Z-72  
(2013)

CEARCREST ROAD TRACT  
FOR  
ZONING PLAN  
LOCATED IN  
LAND DISTRICT 2ND SECTION  
COBB COUNTY, GEORGIA

**PETITION NO:** Z-72

**ZONING COMMENTS:**

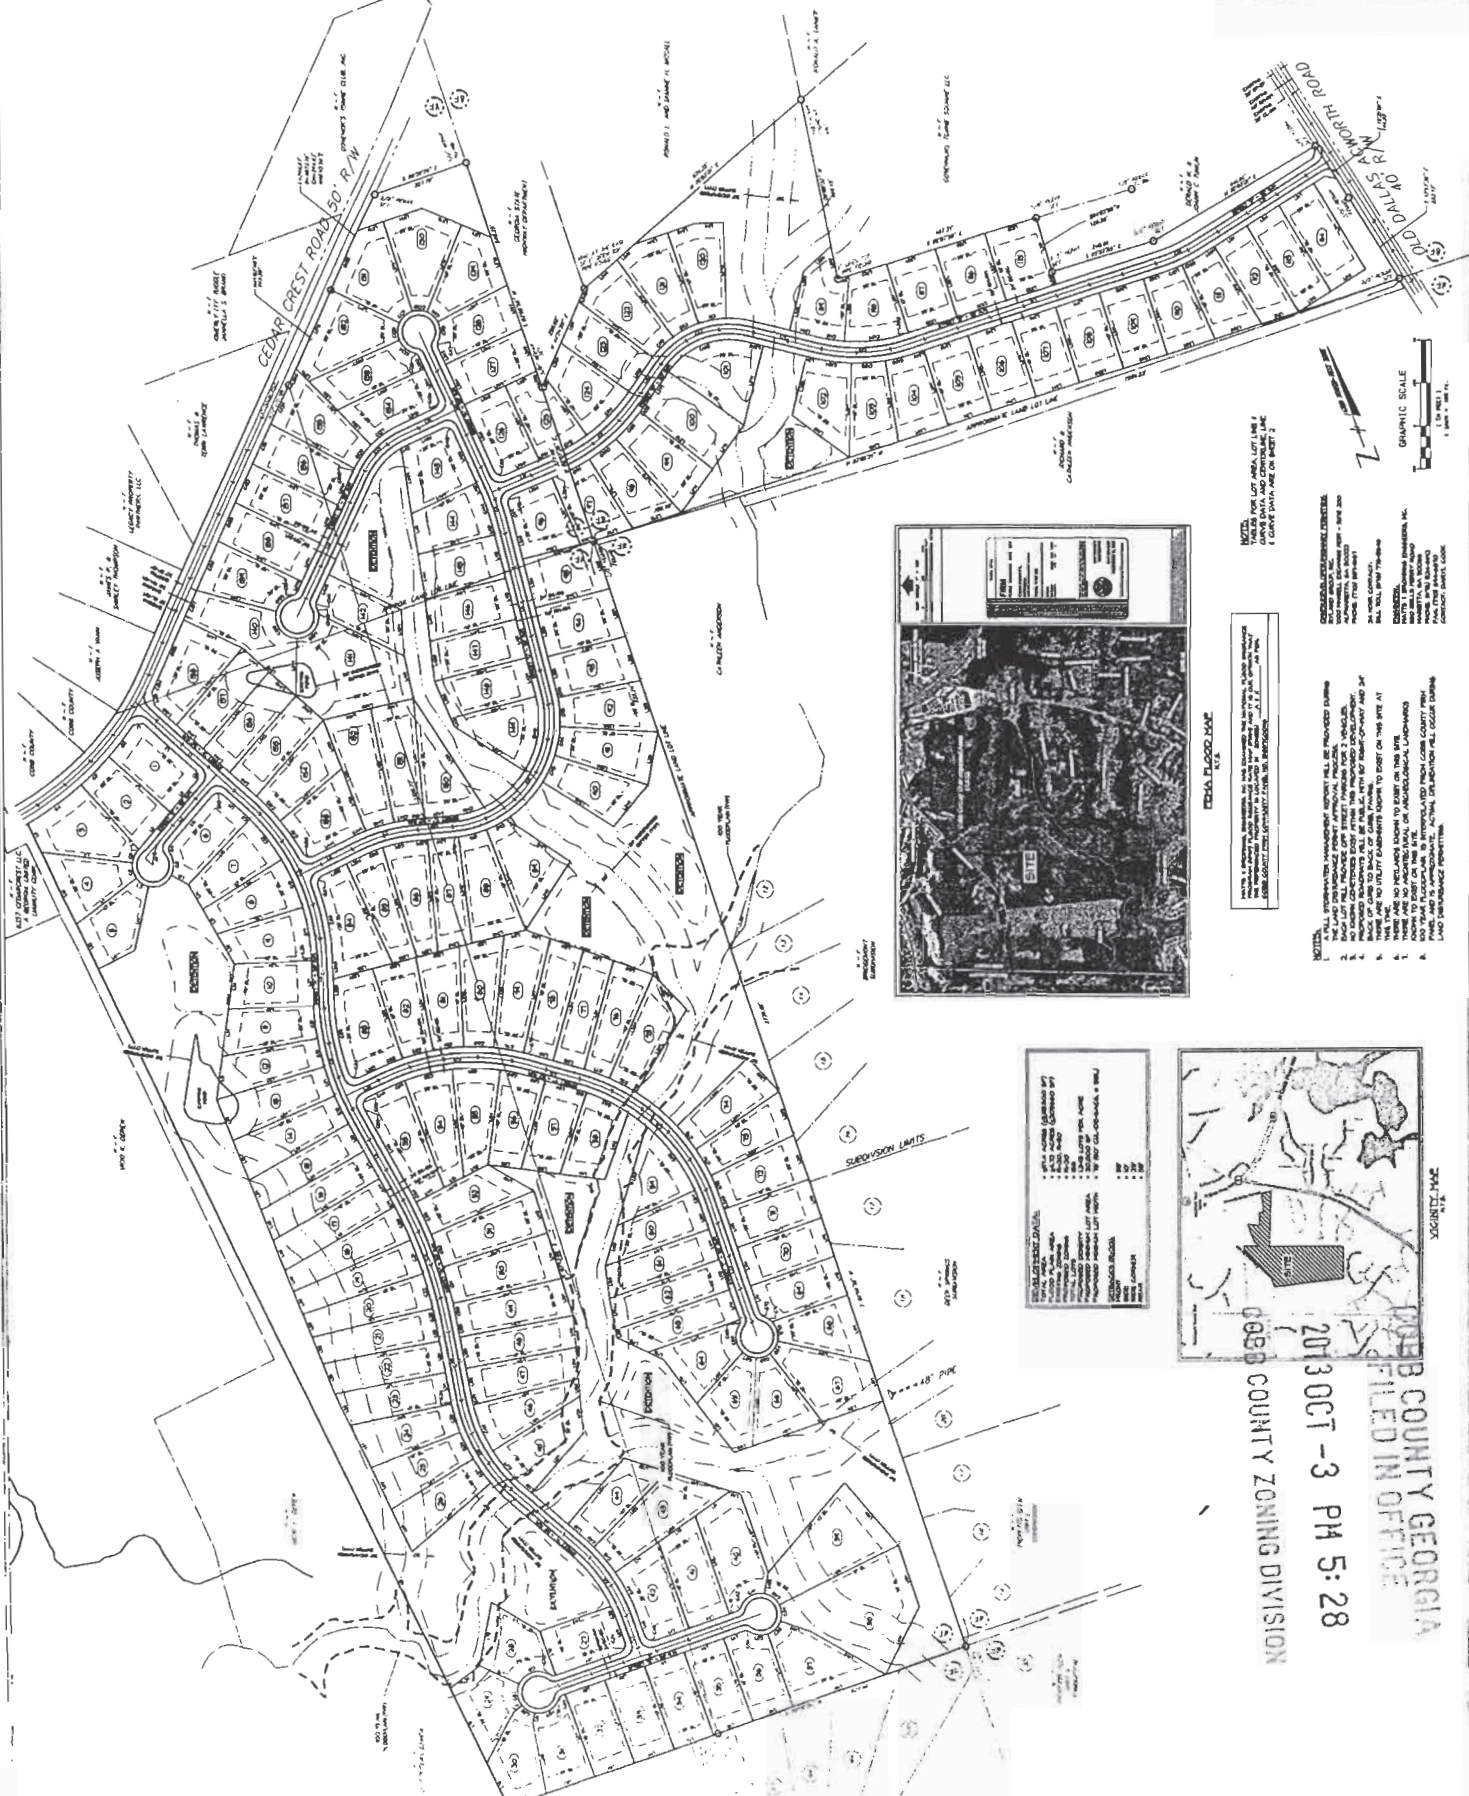
- Provide comprehensive hydrology/stormwater controls to include development of out parcels.
- Submit all proposed site improvements to Plan Review.
- Any **spring activity** uncovered must be addressed by a qualified geotechnical engineer (PE).
- Structural fill \_\_\_\_\_ must be placed under the direction of a qualified registered Georgia geotechnical engineer (PE).
- Existing facility.
- Project must comply with the Water Quality requirements of the CWA-NPDES-NPS Permit and County Water Quality Ordinance.
- Water Quality/Quantity contributions of the existing lake/pond on site must be continued as baseline conditions into proposed project.
- Calculate and provide % impervious of project site.
- Revisit design; reduce pavement area to reduce runoff and pollution.

- No Stormwater controls shown \_\_\_\_\_
- Copy of survey is not current – Additional comments may be forthcoming when current site conditions are exposed.
- No site improvements showing on exhibit.

Cedarcrest Road is classified as a major collector and according to the available information the existing right-of-way does not meet the minimum requirements for this classification.

Recommend coordinating with Cobb County DOT on the Cedarcrest Road widening project. A median is shown at the location of the ingress/ egress.

Recommend a deceleration lane for the ingress on Cedarcrest Road.

Recommend curb, gutter, and sidewalk along the Cedarcrest Road frontage.

- Site plan received by the Zoning Division on October 3, 2013, with the District Commissioner approving minor modifications;
- Architecture to be approved by the District Commissioner;
- Water and Sewer Division comments and recommendations;
- Stormwater Management Division comments and recommendations;
- Department of Transportation comments and recommendations; and
- Owner/developer to enter into a Development Agreement pursuant to O.C.G.A. §36-71-13 for dedication of system improvements to mitigate traffic concerns.
